Summary of M-03A Rev 11 Changes

SOS

June 2016

Exhibit 3: Timeline for PJM Actions in Coordinating Model Update — Sample Summer Process

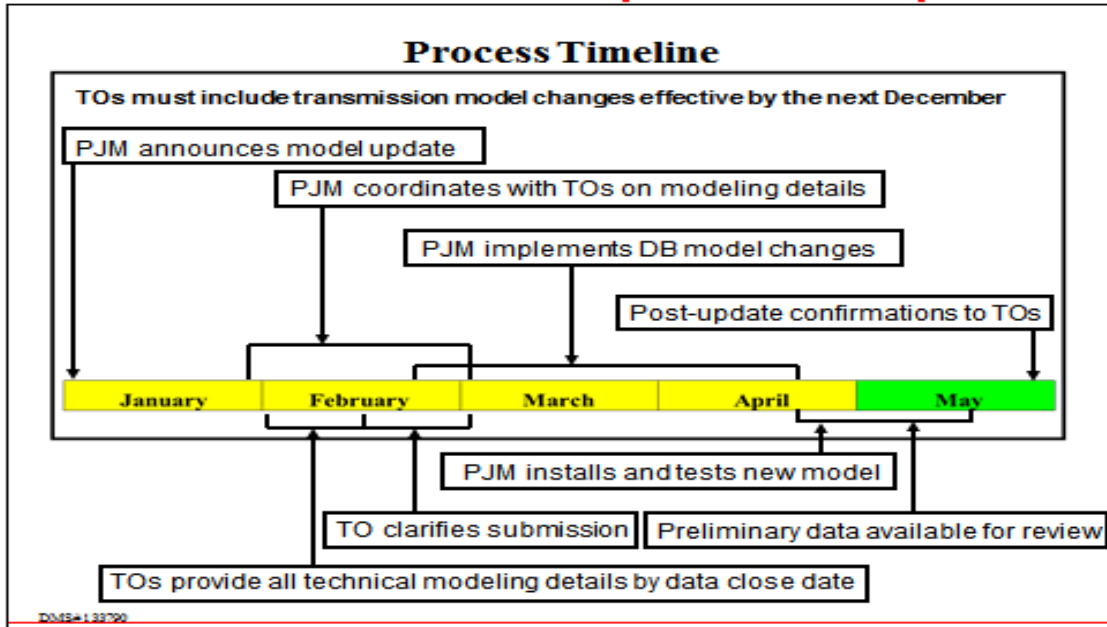
Section 3.2:

- Removed Exhibit 3: Timeline for PJM Actions in Coordinating Model Update - Sample Summer Process since info already covered in Exhibit 4: Network Model Data Submission & Model Validation Timeline
 - Repointed all references to removed exhibit to Network Model Data Submission & Model Validation Timeline exhibit
- Added task for model update testing period to Network Model Data Submission & Model Validation Timeline exhibit
- Adjusted effective model update area with colors to better explain period being modeled and time period to date of model build forward
